## ADDENDUM NO. 2

RE: City of Dierks, Arkansas  
Water System Improvement Project

ADDENDUM DATE: October 31, 2024

Job No.: SCW-02-20  
Scale: 1"=75'  
Date: JULY 2020  
Sheet 11

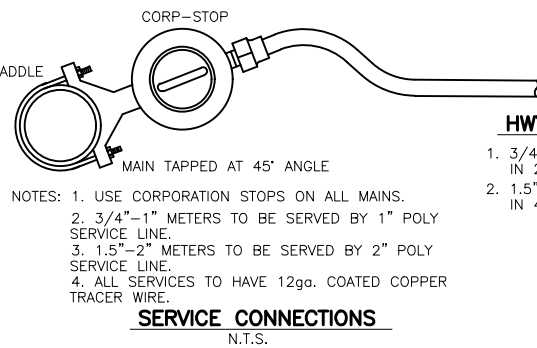
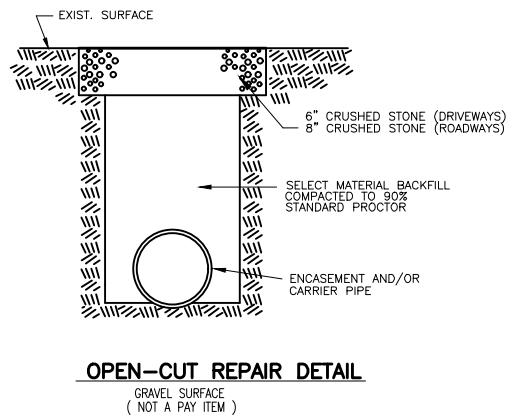
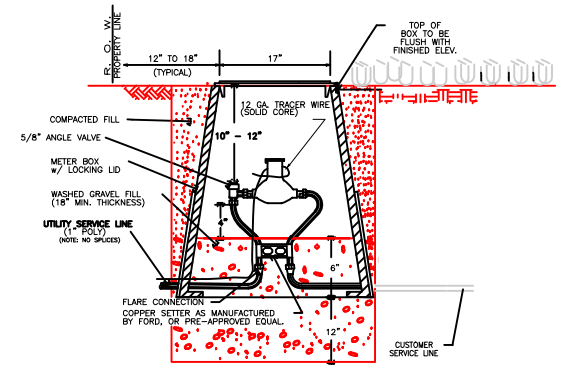
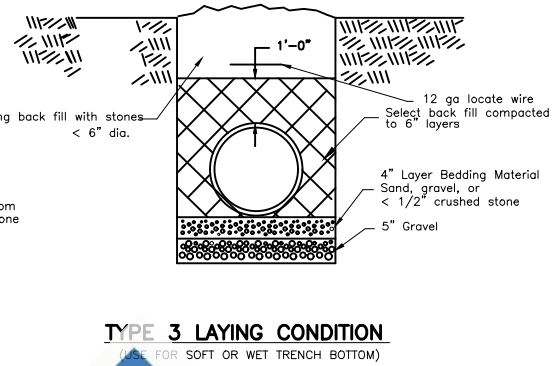
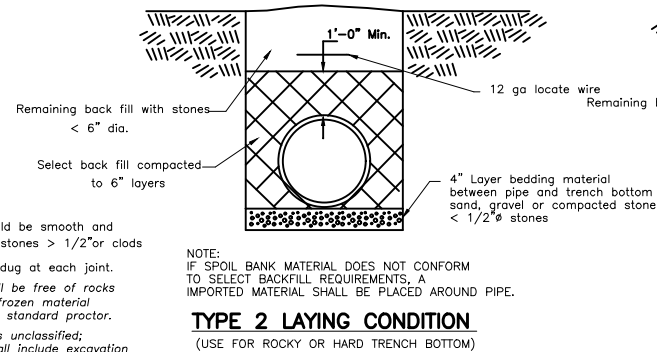
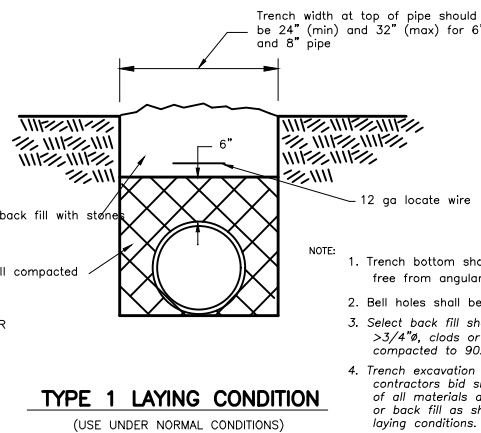
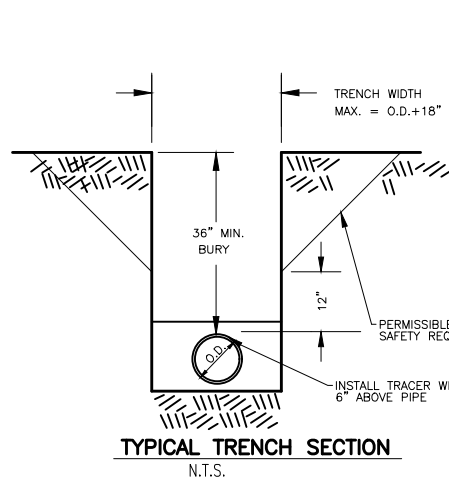
1. **Bid Proposal Revised. Remove and replace with the attached.**
2. **Add Sheet 11 to plans. See attached.**
3. **Clarification-Contractors shall be prepared for Type 2 laying conditions. Reference Sheet 11.**
